CHUGACH ELECTRIC ASSOCIATION, INC.
Anchorage, Alaska

ADDENDUM #2

E2114030
Depot Dr AK Railroad Relocation - SOA

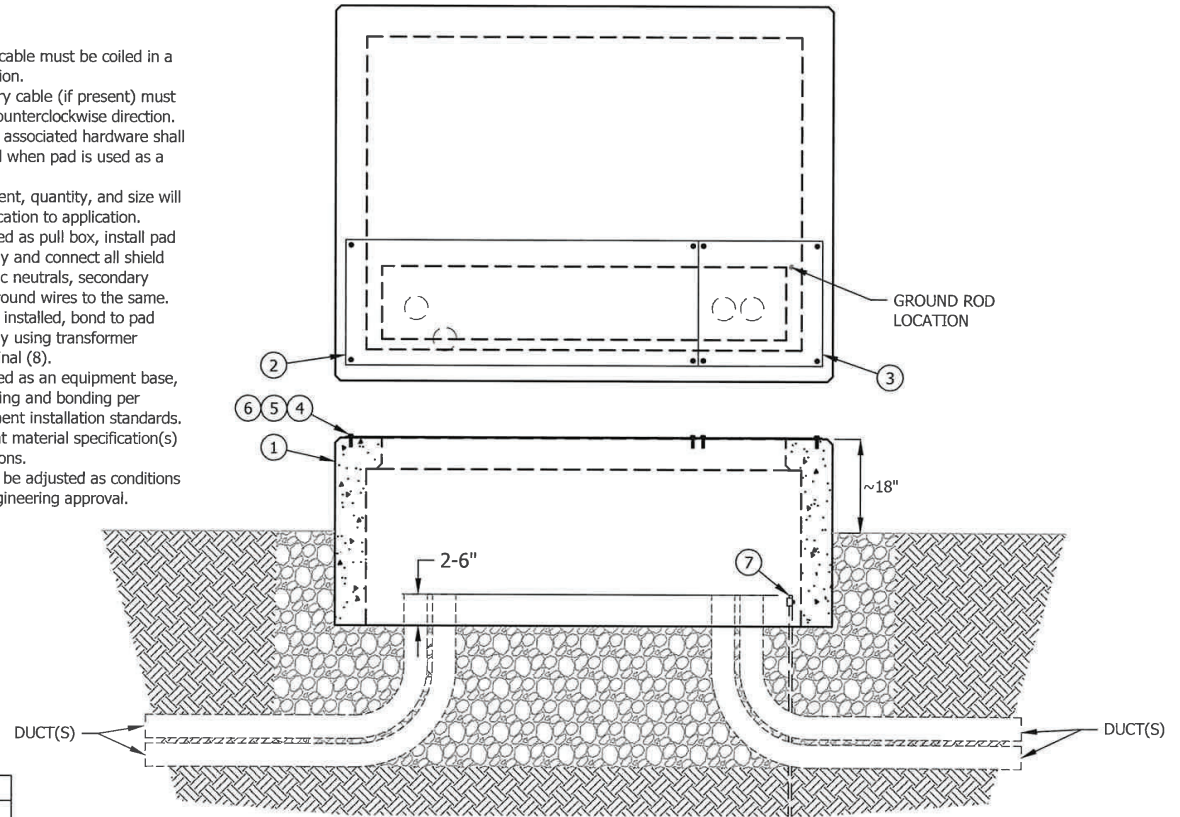
- A CEA warehouse will be providing several partial reels for this project. The length will vary reel to reel.
- Q Will CEA provide the spec for the following units, SUM1-M, SUM6-1J, SUM6-28J, SUM6-28M, SUM6-3J, SUM6-3M and SZUM3-9FI?

- A SUM1-M – 96" x 72" SWITCH CABINET PAD (SEE ATTACHED)
